SEWAGE DISPOSAL SYSTEM

DEPARTMENT OF HEALTH AND MENTAL HYGIENE

P 510570

REPAIR - PURPOSE - SEPTIC SYSTEM HAS FAILED.

P 510570-A 1

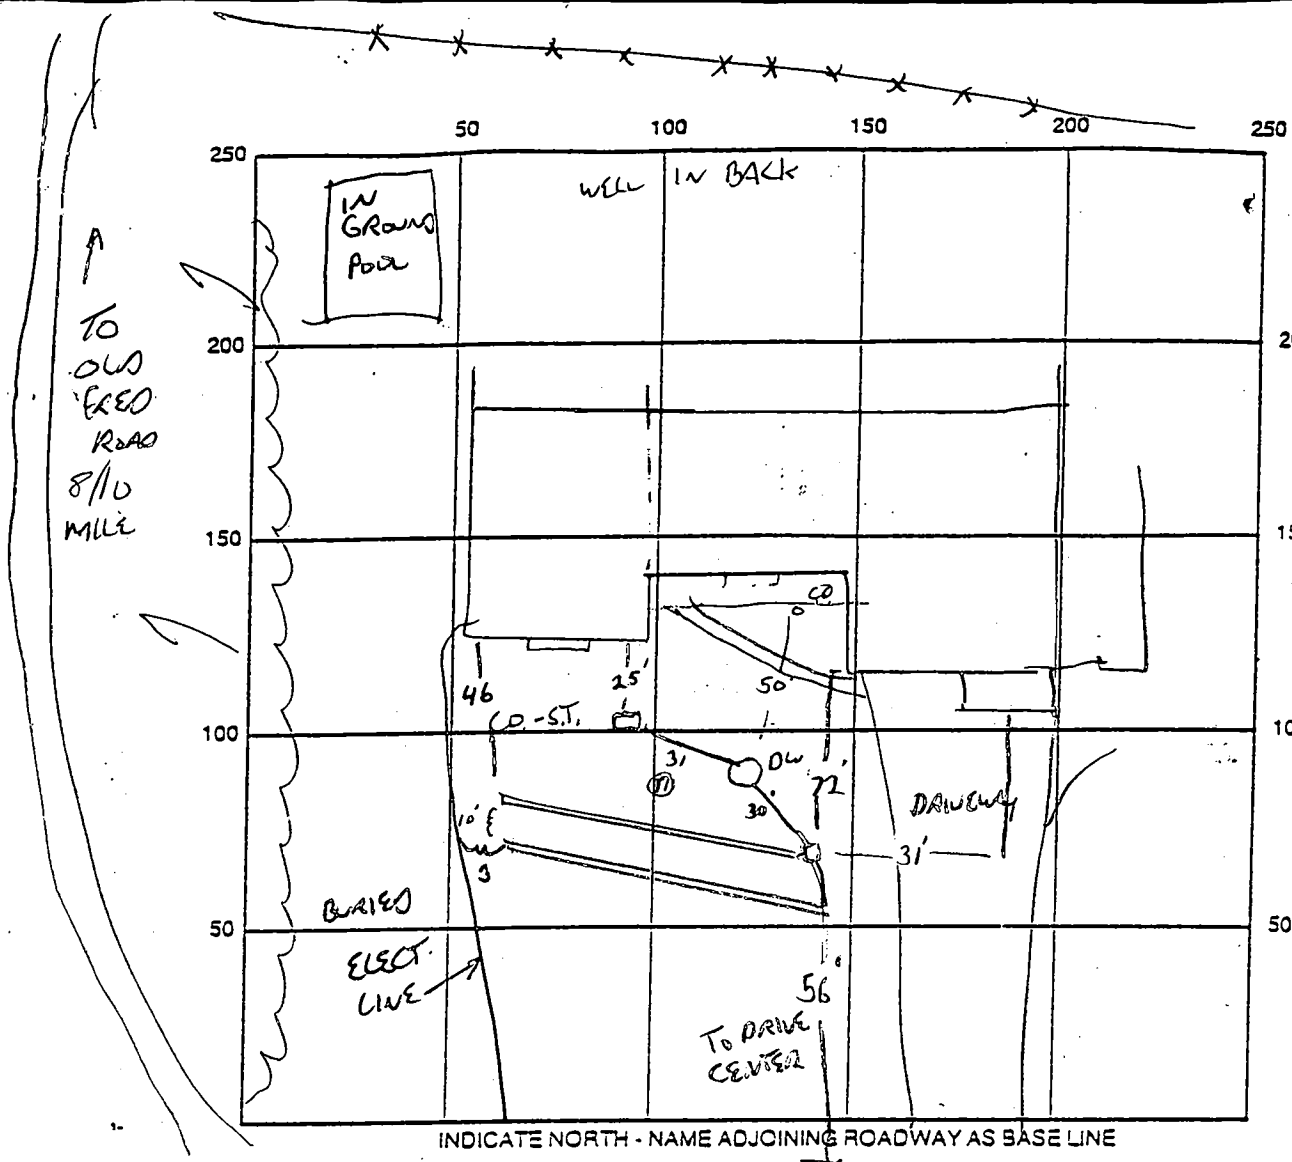
Call for an inspection when the ground is opened so a sanitarian can recommend repairs. 7/15/98.

OK TO VARY DEPTH AT TRENCH ENDS FOR TOPOGRAPHY

2 INSTALL TRENCHES IN FRONT YARD BELOW DRYWELL AS DISCUSSED.

REMARKS: 7-16-98 LINE FROM TANK TO DRYWELL REPLACED, DRYWELL FULL, 1ST TRENCH
DUG, OK TO CONTINUE IN AREA BETWEEN DRYWELL AND DIST BOX GRAVELLED
FINAL, COVERS ALL WORK IN

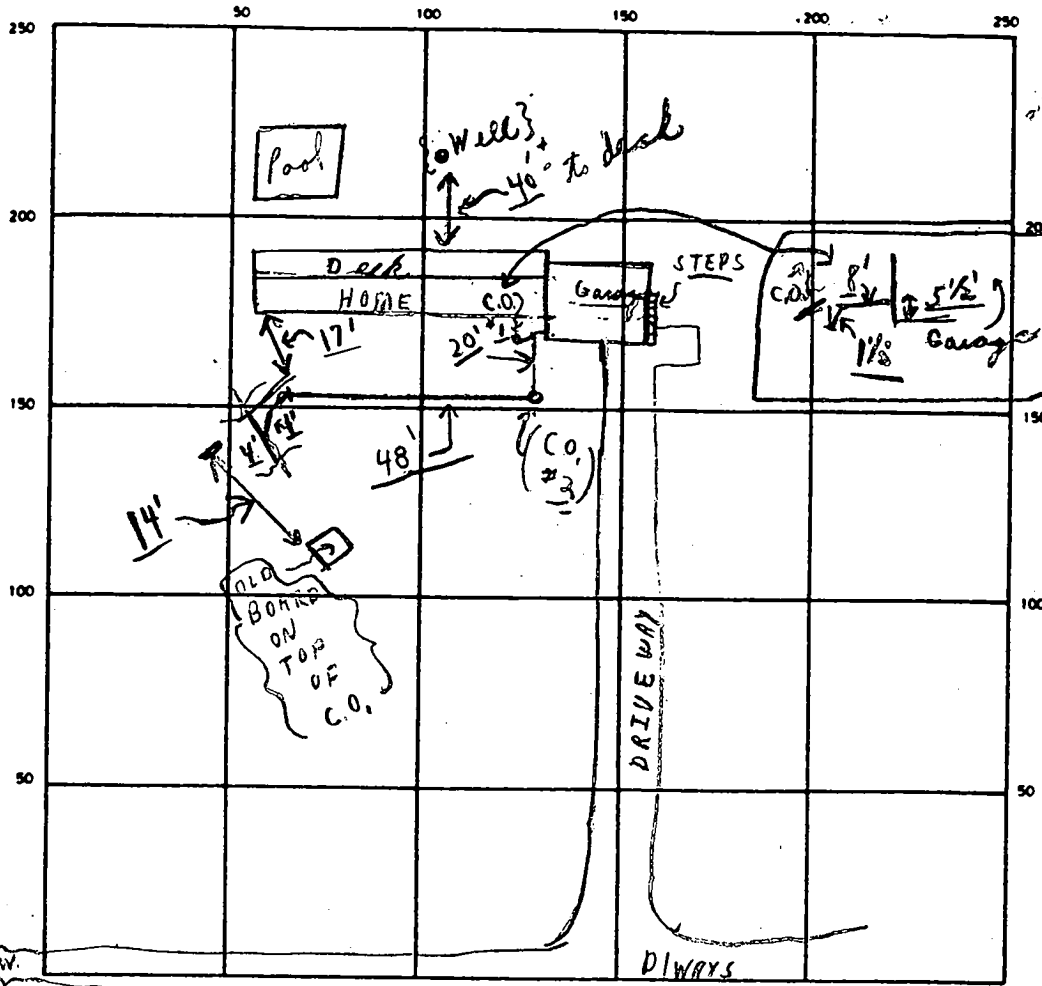
REMARKS 10/3/89 NEW SEPTIC LINE - FOR NEW ADDITION
AND CLEANOUTS ON LINE OK TO COVER - FINAL.

HOUSE DETAIL 1"=50'

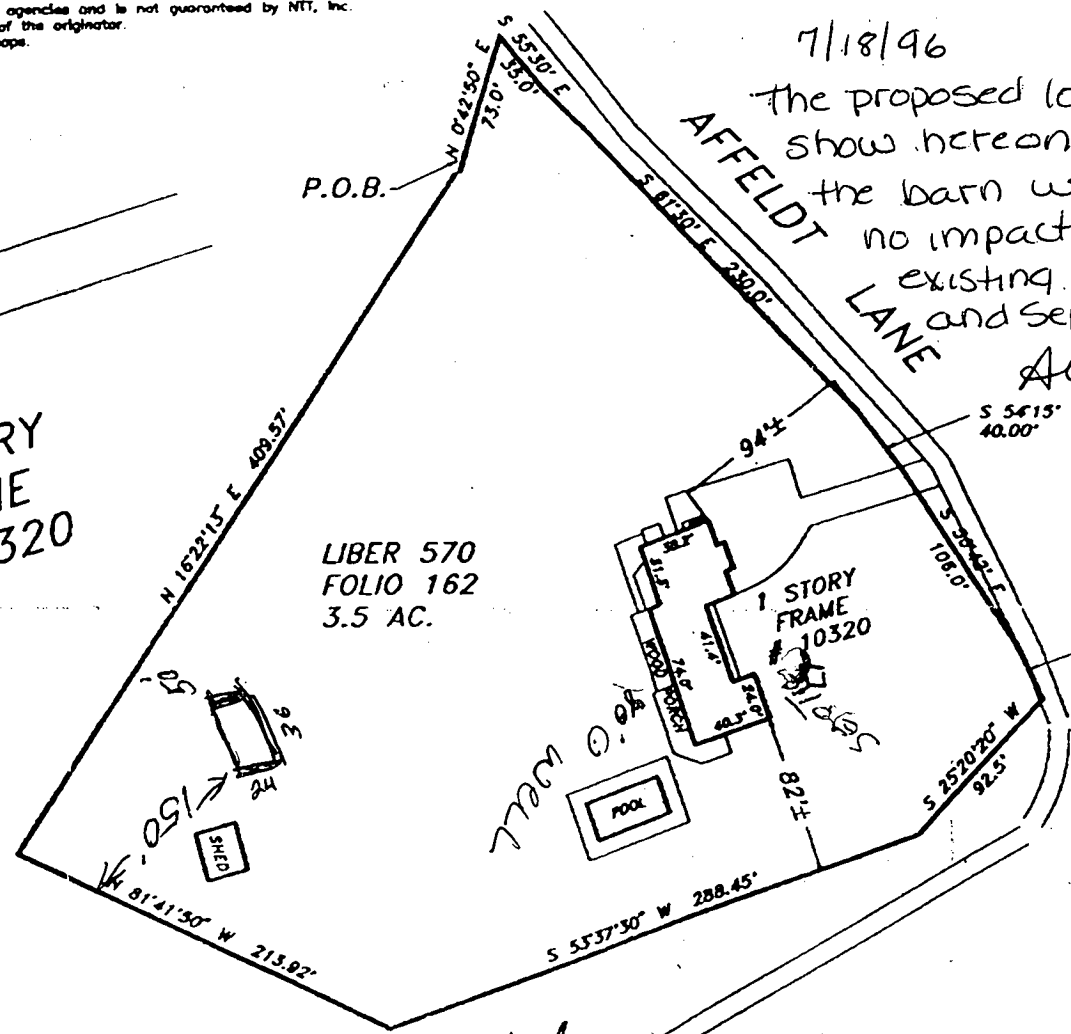
The proposed location show hereon for the barn will have no impact to existing well and septic line
